Jim Sanborn papers

Maintenance Instructions for
The C.I.A. Kryptos Project

Re: Central Intelligence Agency Sculpture

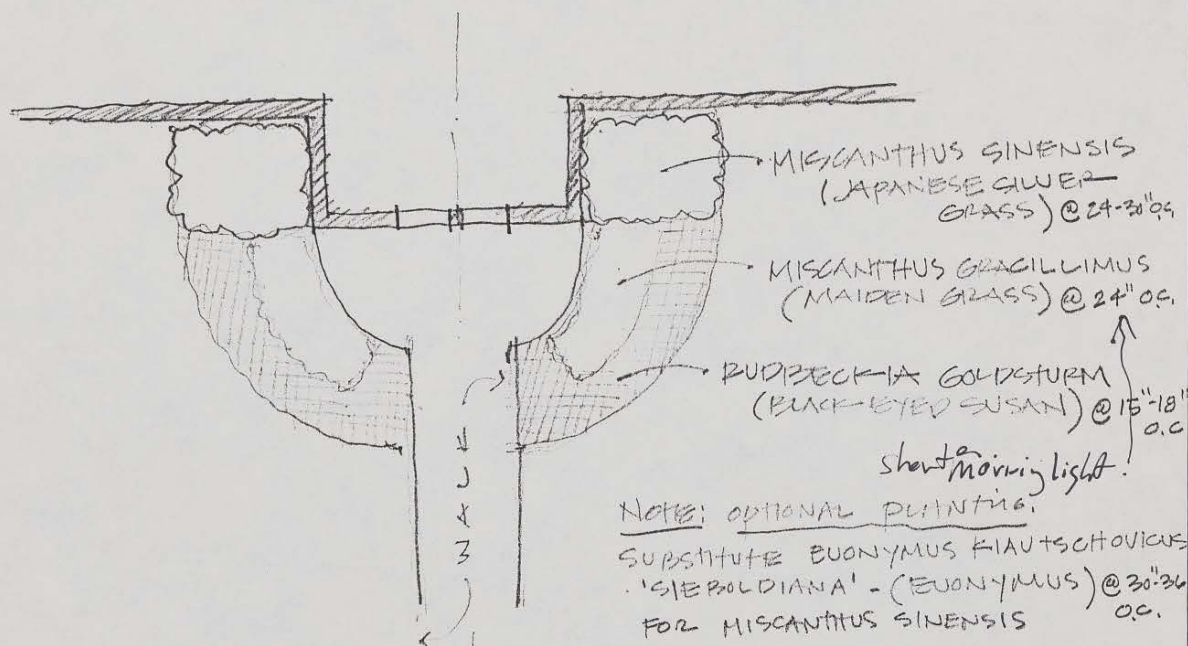
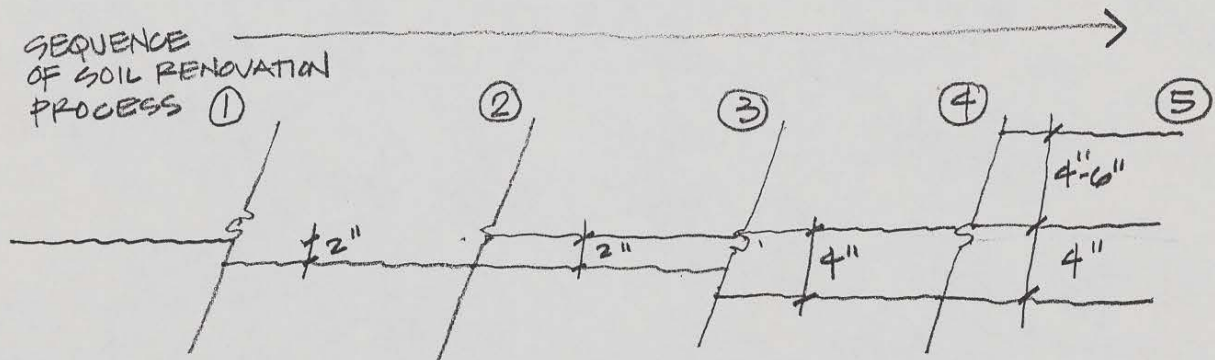
1. Replace dying yews at the entrance door with shrubs, grasses, and perennials (see sketch #1). Add drainage to these beds per sketch #3A.
2. Renovate soil in the lawn and planting areas per sketch #2 & #3 to improve drainage and growing conditions.
3. Remove or change location of P.J.M. Rhododendrons and other existing trees and shrubs as necessary to accent views of the sculpture.
4. Add clusters of Red Oaks on either side of the entry as per sketch #4.
5. Replace the Pin Oaks on the south side of the entry walk adjacent to the cooling tower building. Change soil, add drainage and install per sketch #5.
6. Add drainage and renovate the soil around the Pin Oaks on the north side of the entry walk adjacent to the parking garage per sketch #6.

3A TYPICAL SECTION THRU DRAIN LINE

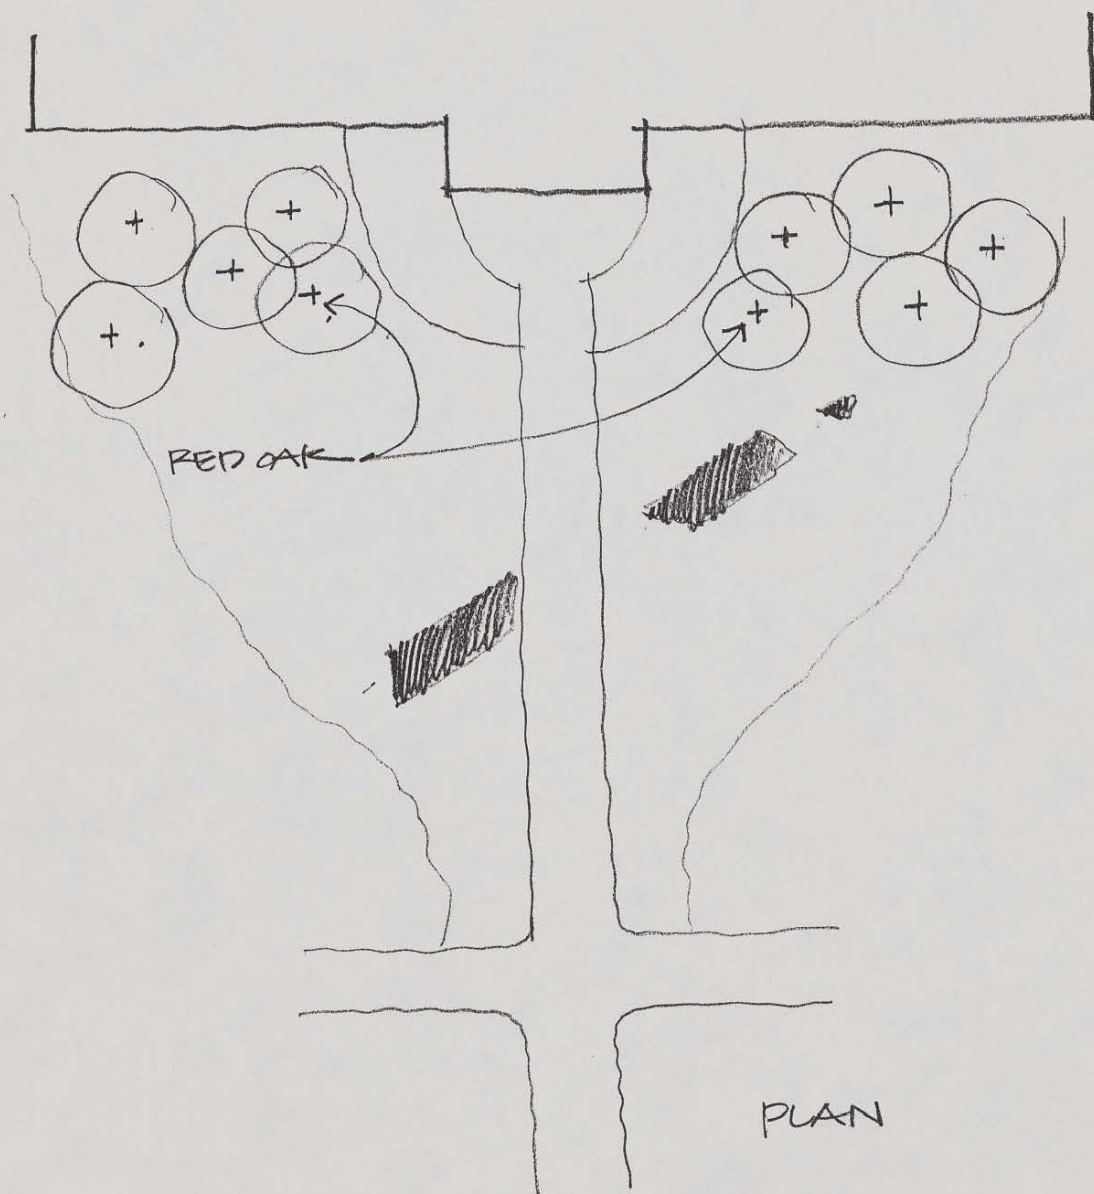
- 4. In replacement lawn areas, till soil prior to installing lawn.
 - 5. Add ornamental grass and vinca ground cover in planter along west side of courtyard. The soil and drainage in these planters is very poor and vinca may not perform well, unless this fact is changed. (See detail 2 and 3A. Connect drain line to weep holes drilled into seat wall.) If drainage is not changed, plant ivy for the groundcover.

7

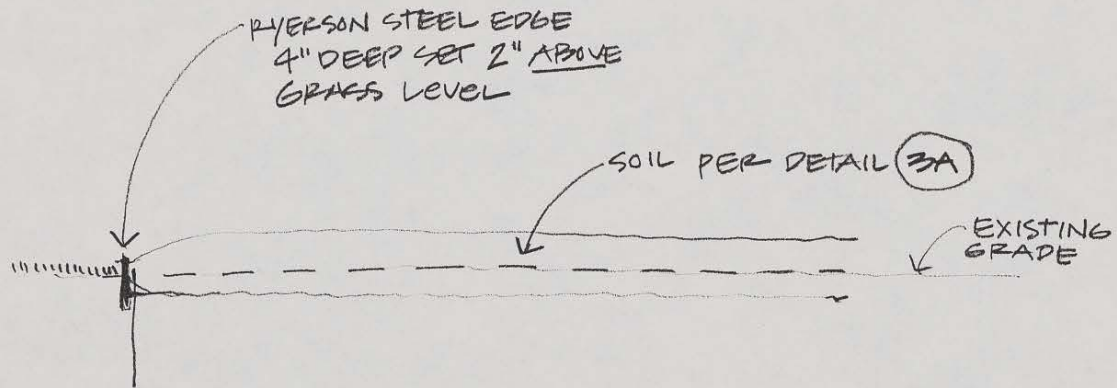
- 2. Add a steel angle (1-1/2" high x 2") along pool edge to increase soil depth at concrete lip.
 - 3. Add ornamental grasses and perennials around sculpture. Make soil modifications per sketch #7.
